Historic District Review Committee

Staff Report March 8, 2010

CAPP 2010-0002 Madison: New Residential Construction in the Waterford Historic District: MCPI 304-46-4671.

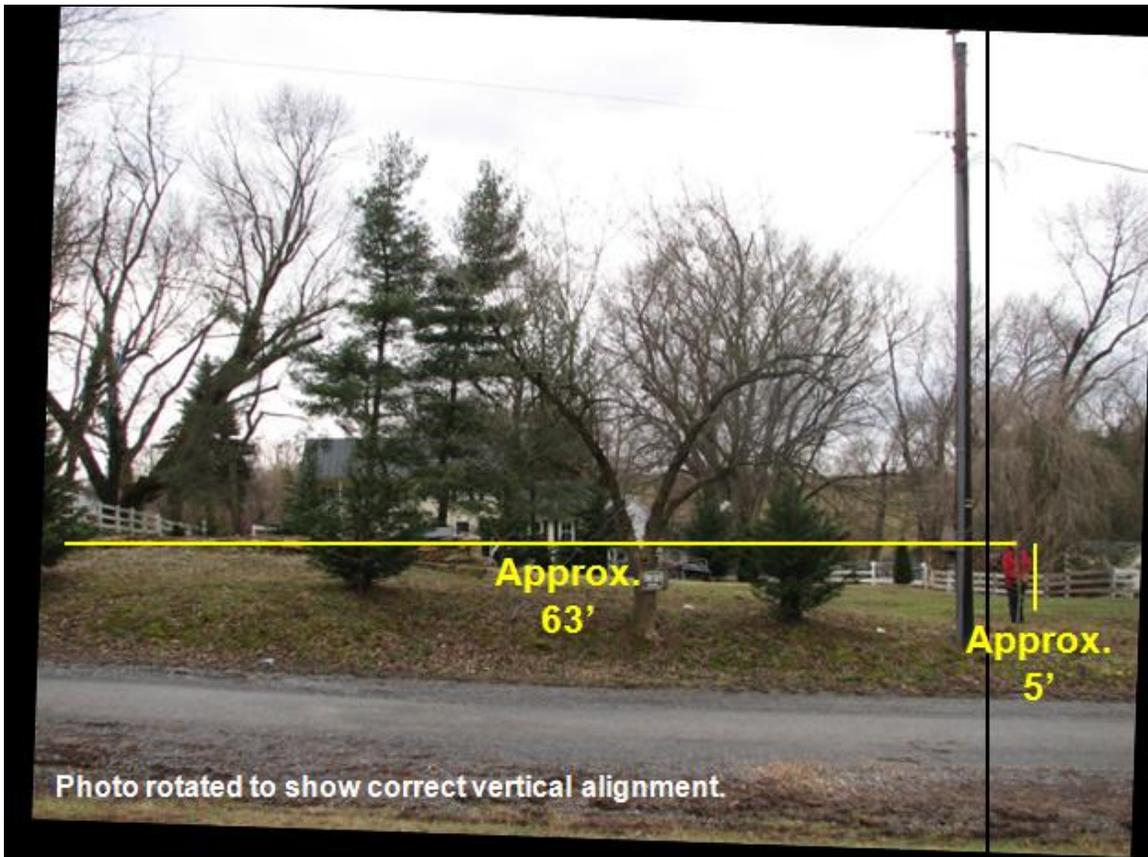
The revised plans do not show the correct change in grade on all elevations. The applicant notes on the plans for the front elevation, "Keep existing grade to left and as much as possible," and on the left (east) elevation, "Grade to be kept as close to original." While these statements are generally unclear, minimizing grade changes and preserving existing landforms and features in their natural state are recommended in the Guidelines. Artificially contouring the landscape should be avoided (*Waterford Guidelines, Guidelines for Site Elements: Landforms and Features, Inappropriate Treatment 1, Guidelines 1 and 2, p. 38.*) Therefore, the proposal to maintain existing grades as much as possible would meet the Guidelines. However, the applicant does not sufficiently address how the change in grade on the west end of the proposed residence will be dealt with and the revised plans still do not accurately depict the grade change.

The change in grade from the northeast corner to the northwest corner of the proposed residence is approximately 5 feet, but could be as much as 6 feet (Figure 1). The revised plans depict the first floor level of the west wing stepped-down 2 feet from the first floor level of the main block in an attempt to accommodate the grade change. Since the applicant states that the grade will be as close to the original as possible, staff questions how the remaining grade change of approximately 3 to 4 feet will be addressed.

The depiction of how the change in grade will be treated on the west elevation of the west wing and in the west side of the rear ell is also unclear. In the revised submission, cellar windows along the west side of the west wing are shown to be partially beneath the ground surface.

Any revised plans must accurately depict the existing topography, the proposed changes in grade, and how the exposed foundation and any other exterior features or details constructed to accommodate the grade will be treated.
